## PRODUCT SERVICE BULLETIN

Bulletin number: SB AMMO071210/1

**Subject:** Substandard loop washers

**Identification:** Loop washers better known as "smiley". In general used in parachute systems

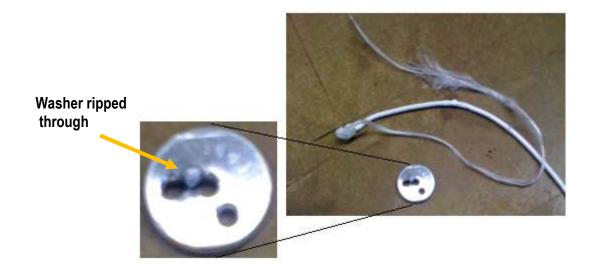
According to this update certain discs can break or rip from hole to hole. The problem is known by the disc supplier since 2009. According to the disc supplier at least 400 are still out in the field.

Due to metal fatique, the disc can break at an unpredictable moment. A broken disc can break the reserve closing loop and cause an untimely opening of the reserve container at a critical time (e.g. floating and landing). Alternatively the damaged loop and/or washer may obstruct or delay the opening of the reserve container or hamper the reserve deployment.

All parachute systems equipped with an Argus AAD should have their disk checked and replaced after each repack. We highly recommend to replace all smiley washers by stronger steel washers using a figure 8 knot for the loop. Free steel washers will be supplied upon request to all Argus users with mentioning serial number and date of manufacture.
